LINCOLN PARK PLANNING COMMISSION
CITY HALL – COUNCIL CHAMBERS 1355 SOUTHFIELD ROAD
LINCOLN PARK, MICHIGAN

River's Edge Apartments Special Land Use Review

River's Edge Apartments Site Plan Review

RIVERS EDGE APARTMENTS

ARCHITECTURAL SITE PLAN

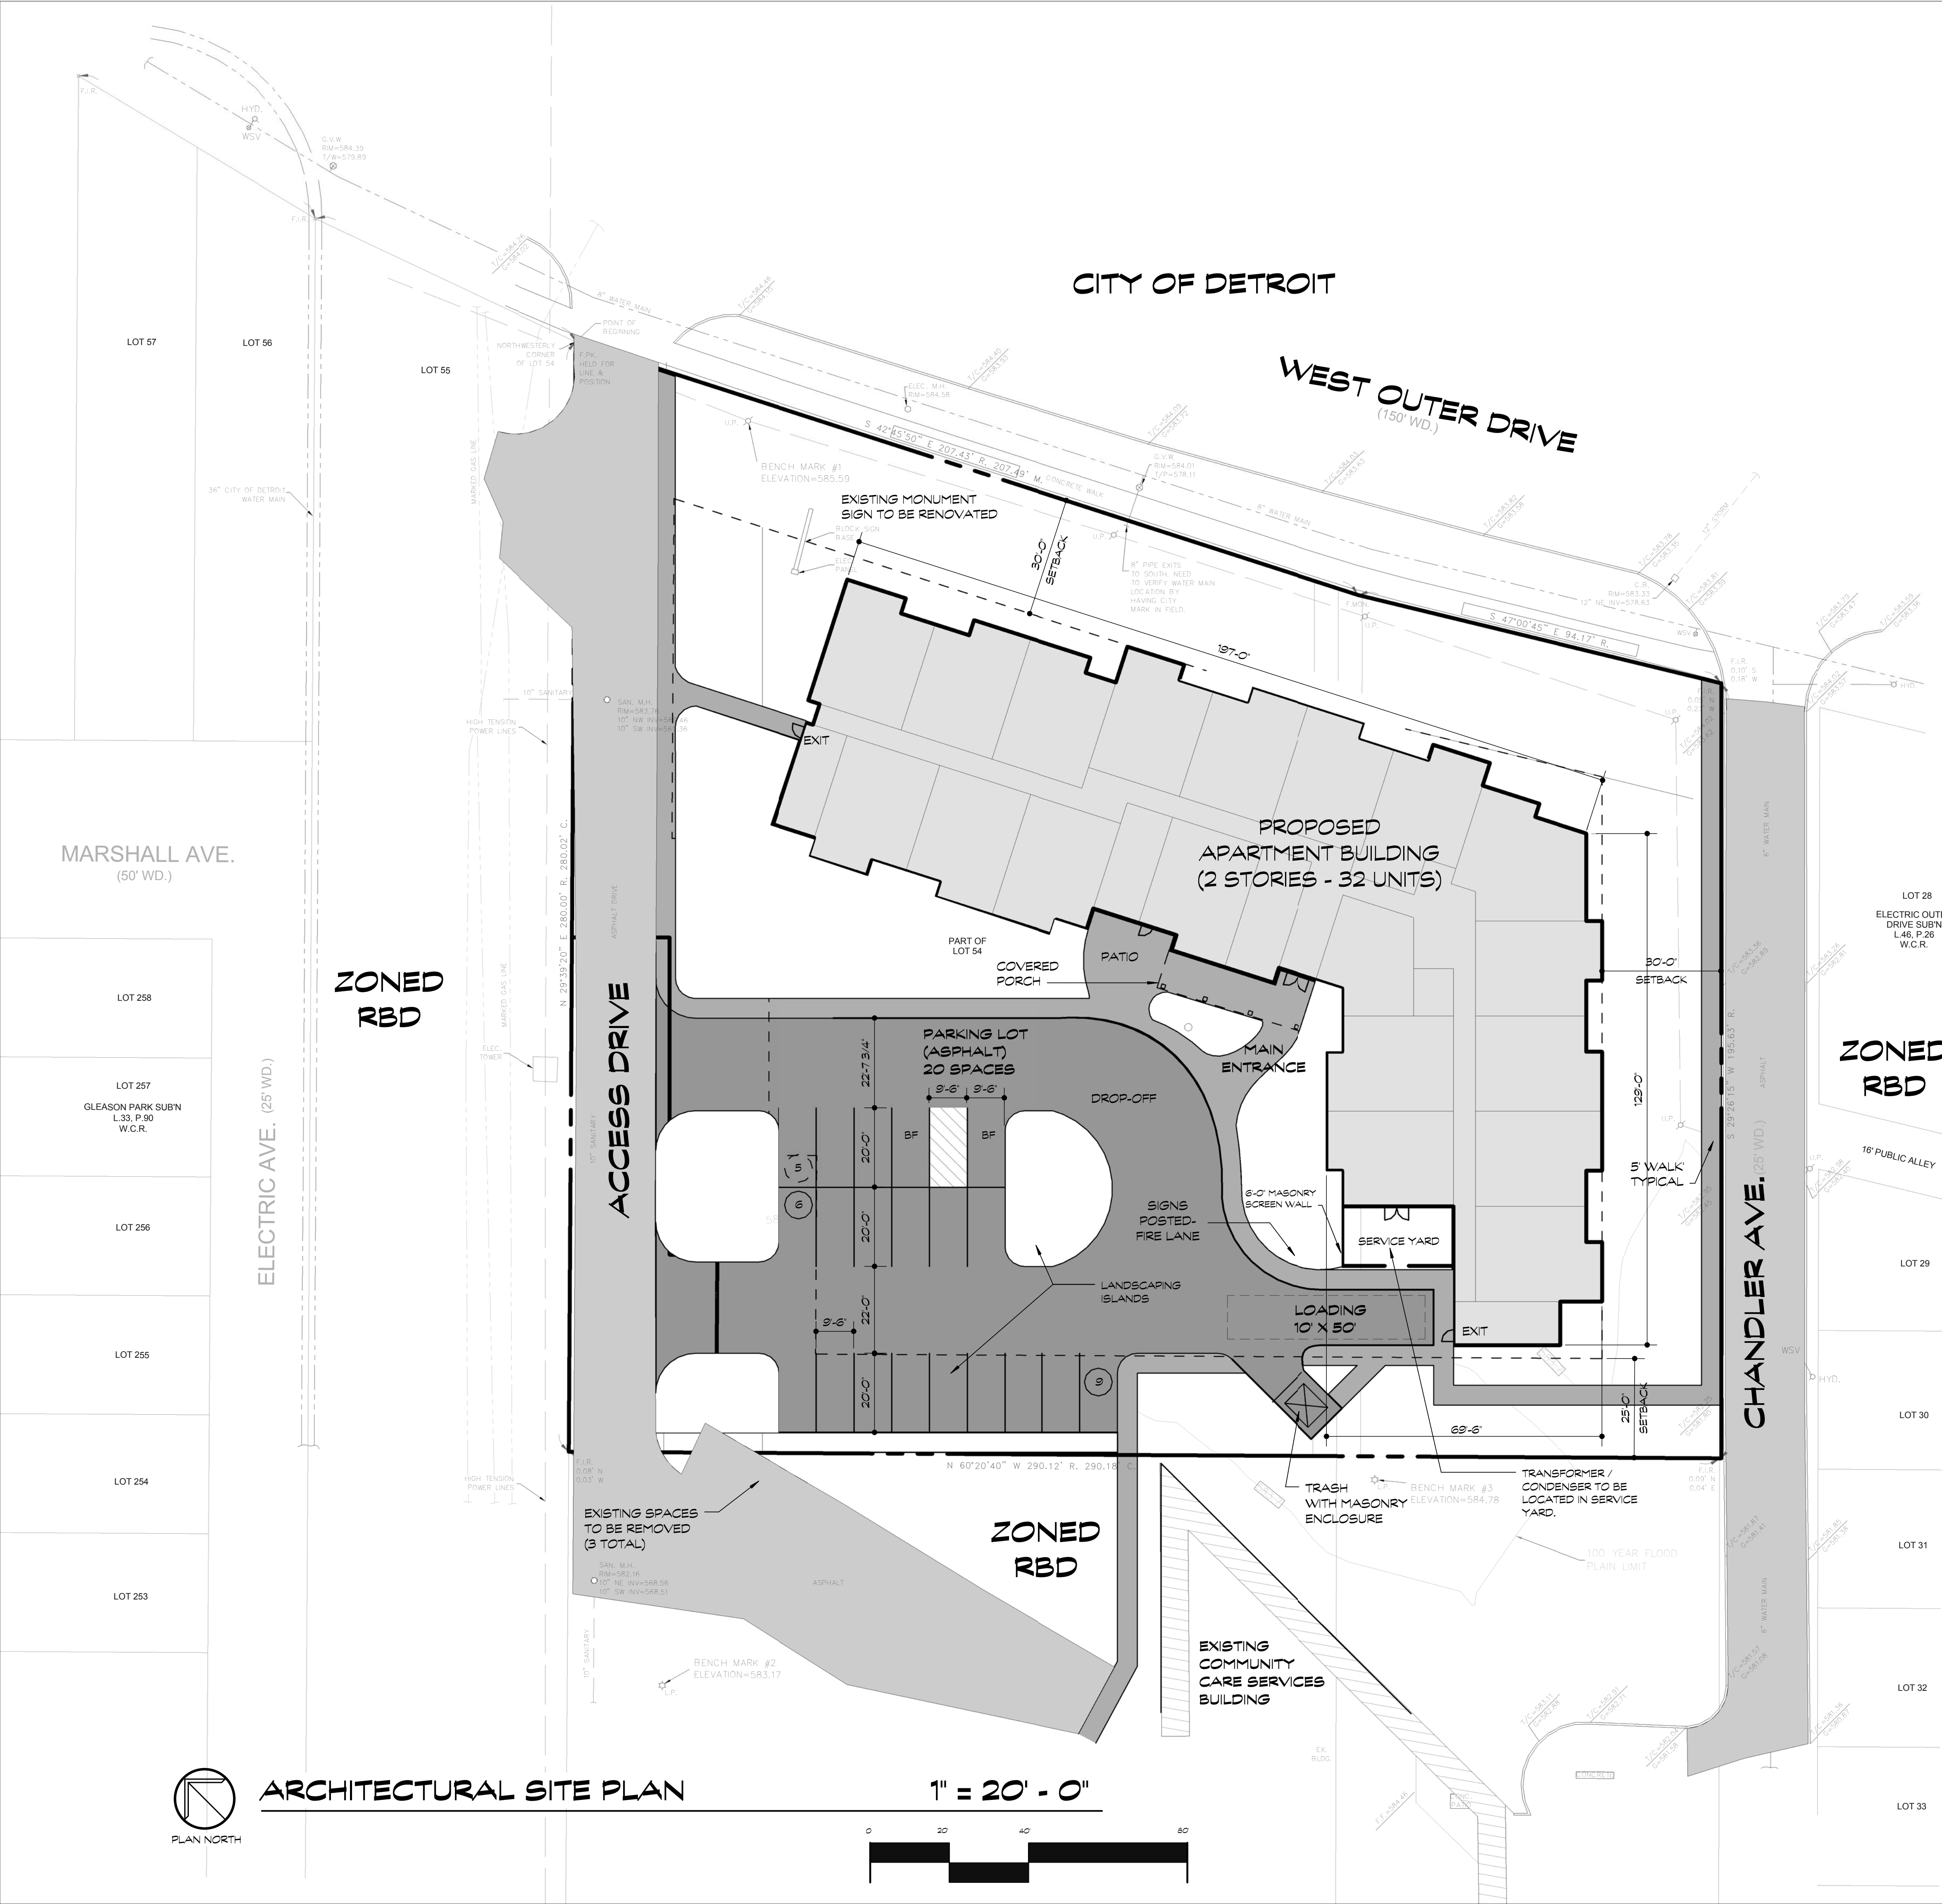
Required Spaces	Required Barrier-Free Spaces	Proposed Barrier-Free Spaces	Compliance
>25	1	0	Not met

- Applicant to label and identify at least one barrier-free parking space
